CITY OF KNOXVILLE CLOSURE OF PUBLIC RIGHT-OF-WAY

▶ FILE #: 11-B-22-SC

▶ RIGHT-OF-WAY TO BE CLOSED: McCalla Ave.

▶ LOCATION: Between its southwest intersection with Pelham Rd and its northern terminus at Rutledge Pk

File No. 11-B-22-SC (Electric)

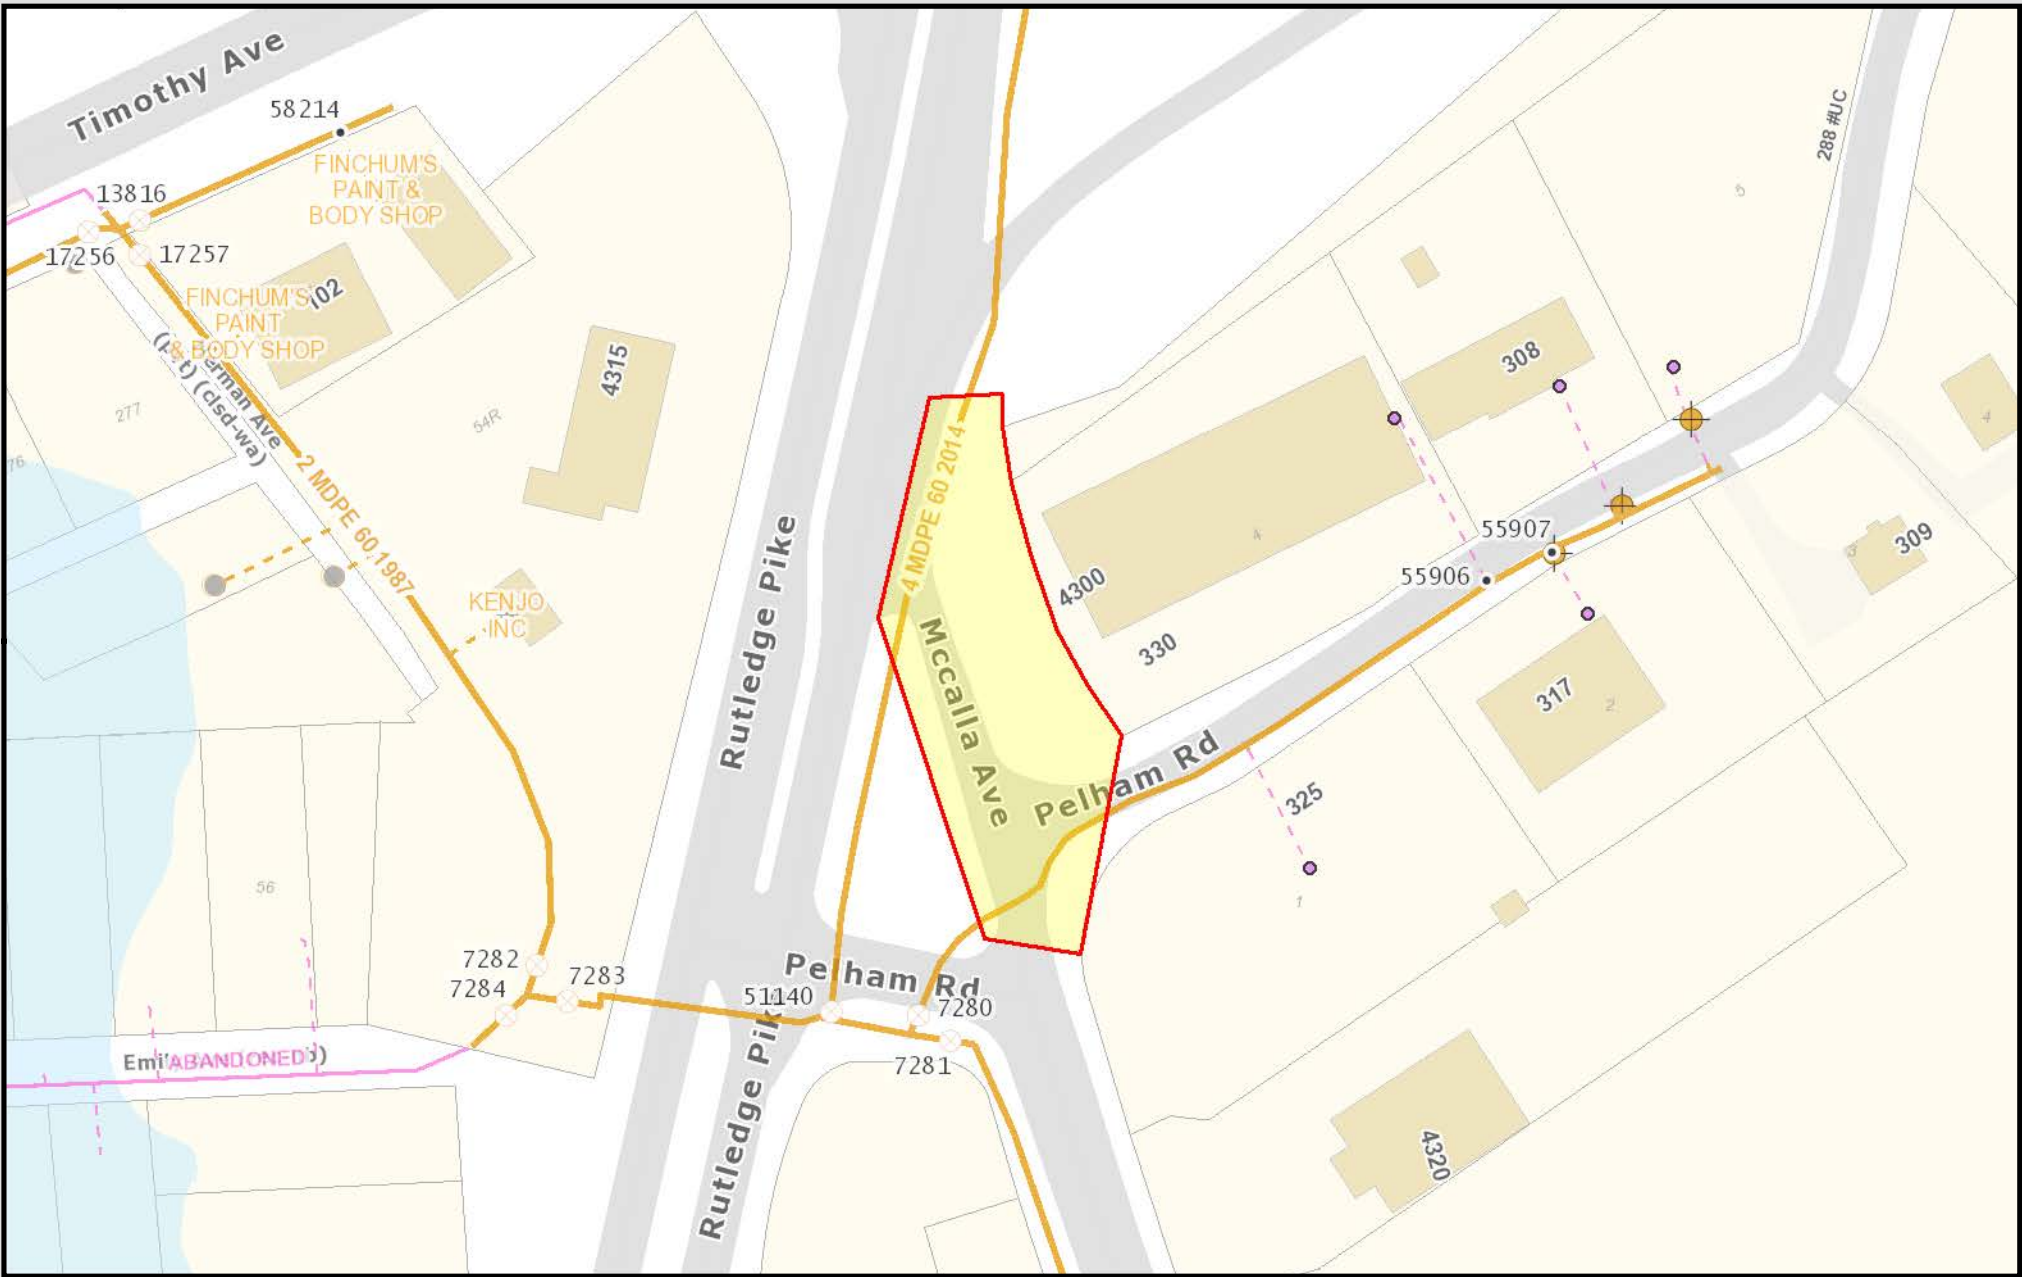
We have reviewed our records and find that we have existing utility facilities located within the subject right-of-way. The approximate locations of these facilities are indicated on the enclosed prints. However, KUB does not release and hereby retains all easements and rights for existing utility facilities, whether or not shown on these prints.

Electric - 10 feet on each side of the centerline of the electric line, 20 feet total width
Gas – 7.5 feet on each side of the centerline of the gas line, 15 feet total width
Sewer – 7.5 feet on each side of the centerline of the sewer line, 15 feet total width
Water – 7.5 feet on each side of the centerline of the water line, 15 feet total width
